# **JPI Addison Heights PD Rezoning (1843-Z)**

# Case 1843-Z JPI Addison Heights PD Rezoning

Approval to rezone the property from Commercial-2 (C-2) to a Planned Development (PD) District with modified Urban Center (UC) District standards for multifamily residential, live/work, and future retail uses.

## MITIGATION OF DEVELOPMENT IMPACTS – TRAFFIC GENERATION AND CIRCULATION

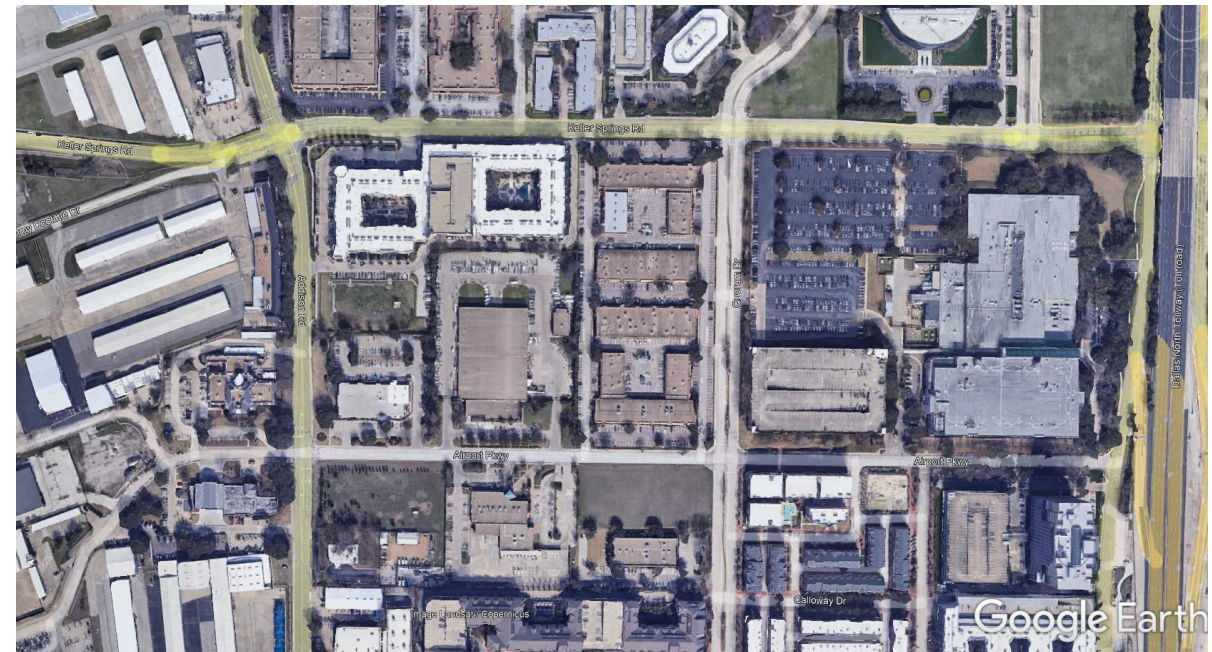
- A Traffic Impact Analysis (TIA) was required for this proposal
- Site is in a highly connected area with convenient access to DNT and Belt Line
- Site generated traffic and anticipated future growth will not result in a reduction in the level of service at any of the surrounding signalized intersections
- For the project access drive connecting to Addison Road, exiting traffic should be limited to right-turn only onto Addison Road
- Pedestrian connectivity is improved through sidewalk improvements and new access to Addison Circle

## DEVELOPMENT WAIVER REQUESTS – OPEN SPACE DEDICATION

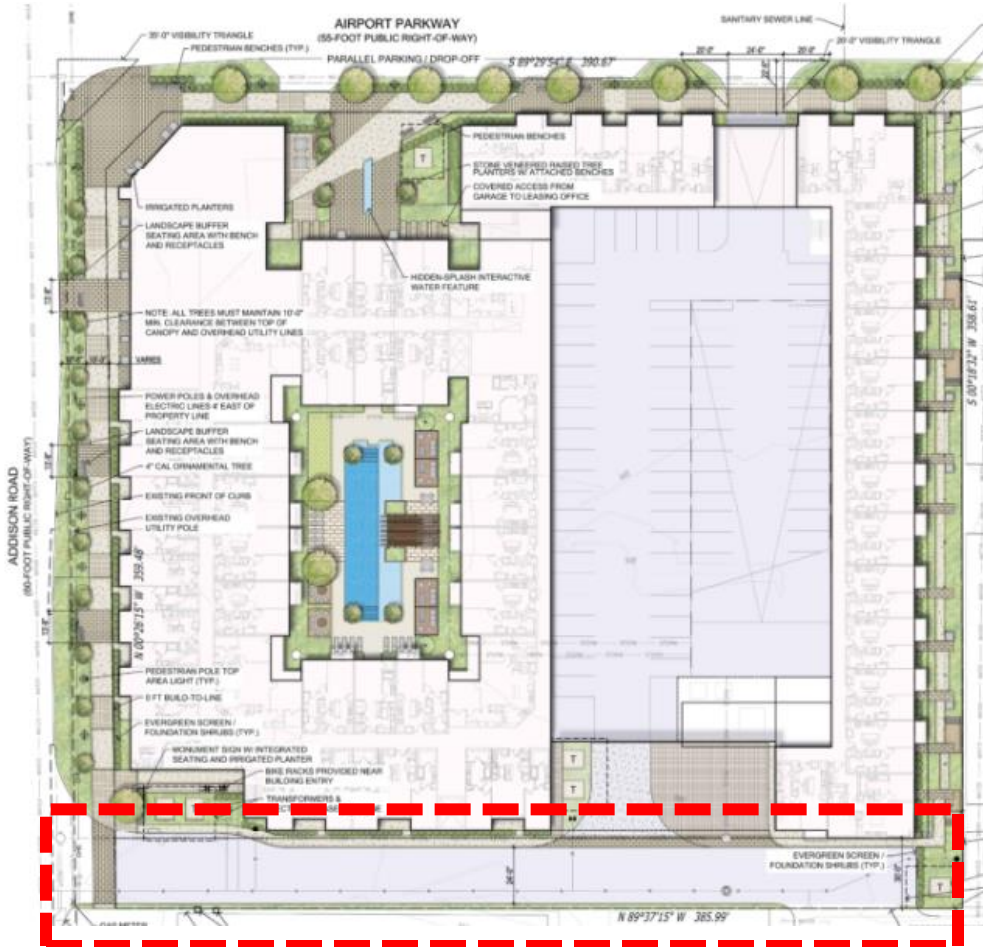
- UC District requires Public open space to be dedicated for residential use
- In lieu of dedication, applicant is providing:
  - 4,260 SF of publicly accessible private open space + implementation of trail master plan at Addison Road and Airport Parkway + additional pedestrian area at eastern frontage, and pedestrian connection to Addison Circle to the SE
- The Special Area Study and the Parks master Plan did not envision additional open space at this area
- AMLI Addison received consideration for pedestrian connectivity improvements in lieu of public open space dedication; similar consideration should be applied here

## DEVELOPMENT WAIVER REQUESTS – DWELLING UNIT AREA

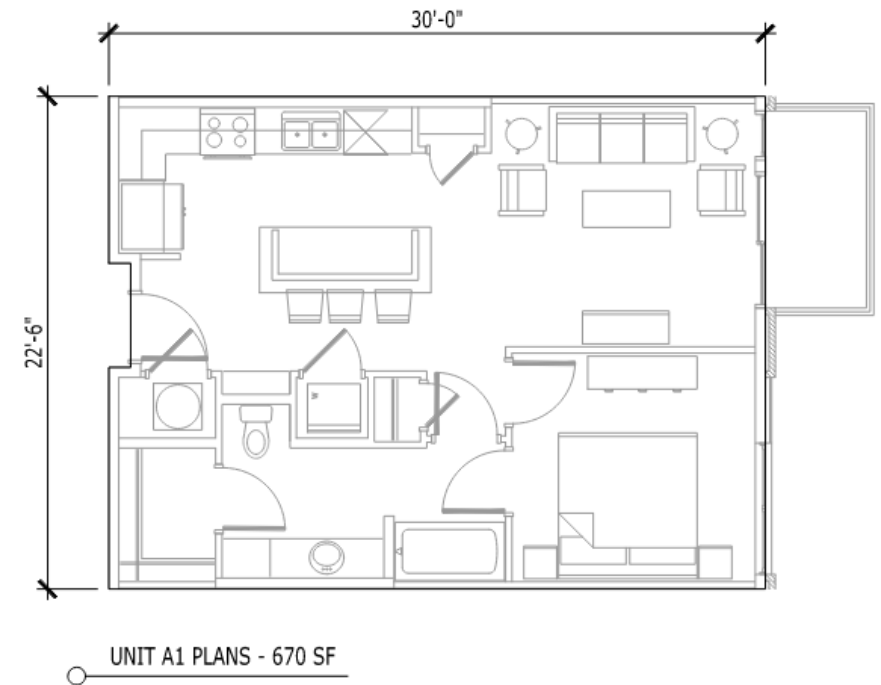
- UC District requires 1 Bedroom units to be a minimum of 700 SF, 650 SF minimum was requested
- 75 1 Bedroom units are 670 SF NET; a private balcony is provided for each of these units
- Based on market research, all other unit sizer requirements are met
- After Addison Circle, a 600 SF minimum was established for Vitruvian
